**Request IR-1:**

**Refer to M12619, Exhibit N-1, the Application for Approval of NS Power’s 2026 Annual Capital Expenditure (ACE) Plan (the “Application”), Page 22 of 782, Section 4, Annual Capital Expenditure Plan Follow Up, and item 4), which states:**

2026 Annual Capital Expenditure (ACE) Plan (NSEB M12619)  
NSPI Responses to Small Business Advocate Information Requests

**Figure 56: Evergreen IRP vs. 2026 ACE Plan Forecast Comparison by Unit<sup>1</sup>**

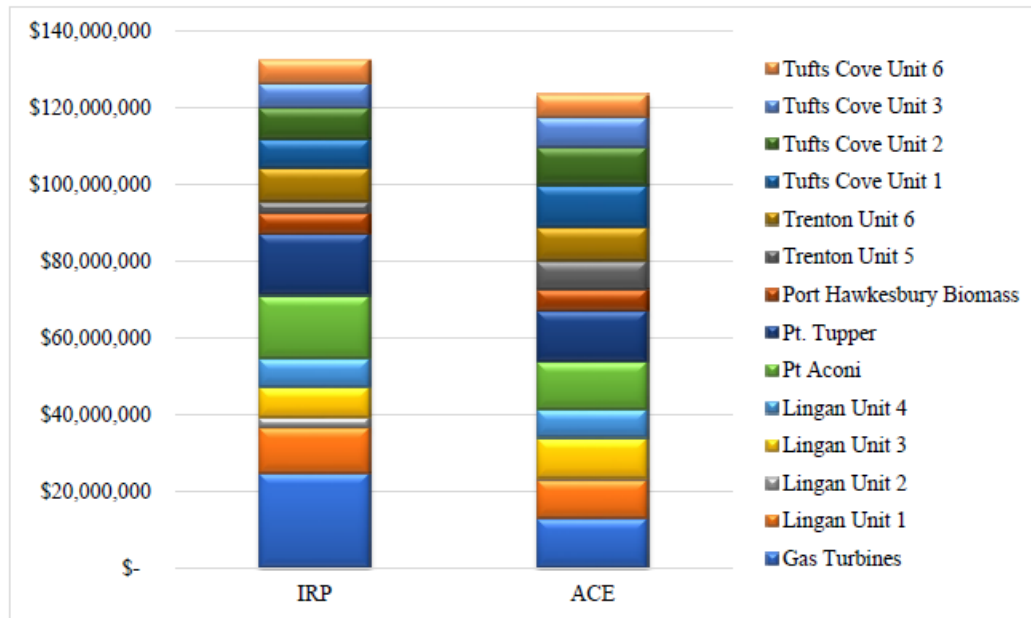
**(a) Compared to the amount of investment in the last IRP shown on the left axis, please confirm which units shown on the right axis:**

**(i) have increased investment planned for 2026.**

**(ii) Have decreased investment planned for 2026.**

1 **(b) Please explain which of the CEJC rating criteria listed on Page 89 of 782, Lines 4-12**  
2 **were relied on to determine this positive or negative change in investment level for**  
3 **each unit.**

4 **(c) Does NS Power expect or plan to have average annual investment levels for these units**  
5 **revert to the IRP planned amounts and if so, when?**

9 (a) (i-ii) The units that have increased investment planned for 2026 are Lingan Unit 3, PH  
10 Biomass, Trenton Unit 5, and Tufts Cove Unit 1, 2 & 3.

11  
12 The units that have decreased investment planned for 2026 are Gas Turbines,  
13 Lingan Unit 1,2 & 4, Pt. Aconi, Pt. Tupper, Trenton Unit 6, And Tufts Cove Unit  
14 6.

15  
16 (b) All three of those rating criteria (Health & Safety, Environment /Regulatory Compliance  
17 and Business Sustainability) are used when determining the 2026 investment plan. The  
18 2026 investment plan is not an update to the Evergreen IRP, rather, the 2026 investment  
19 plan utilizes a bottom-up approach in assessing the risk of all assets and determining what  
20 assets require capital investment to complete risk mitigation activities. The graph in Figure  
21 56 of the 2026 ACE Plan Application shows a comparison between the long-term planning  
22 exercise completed in the Evergreen IRP and the near term, bottom-up plan built on an  
23 annual basis for ACE Plans.

24  
25 (c) While investment levels in future years may be well aligned with the future forecasts in the  
26 Evergreen IRP, NS Power does not build its near-term forecast for ACE Plan purposes with  
27 the intention to align with the IRP forecast. Variances as seen in the comparison above,  
28 either as negative or positive variances, are not significant enough to alter what the IRP  
29 process would have chosen as the best approach to meet the system's generating needs.

**Figure 67: Annual Tree Contact – Customer Interruptions (Major/Extreme Events Removed)**

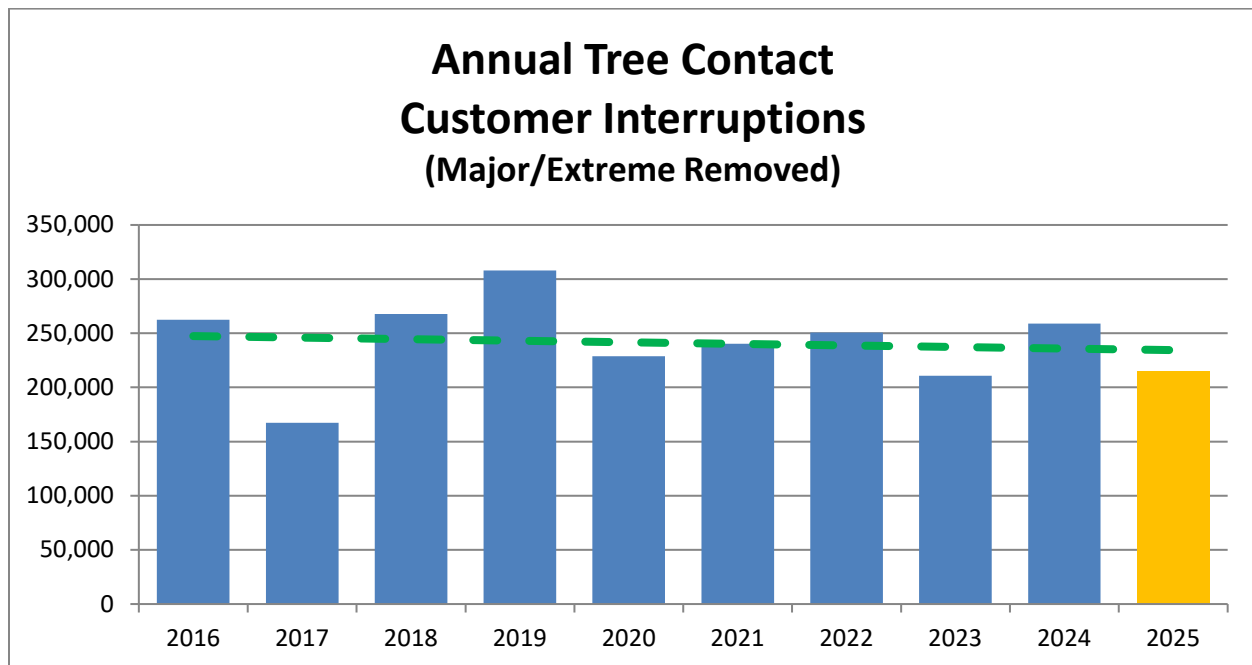
**Please refer to the Application Page 108 of 782, Figures 67: Annual Tree Contact – Customer Interruptions (Major/Extreme Events Removed) and Figure 68: Annual Tree Contact – Customer Hours of Interruption (Major/Extreme Events Removed).**

**(a) Please provide an updated version of both figures with the remainder of the 2025 results included.**

**(a) Please refer to the updated figures below.**
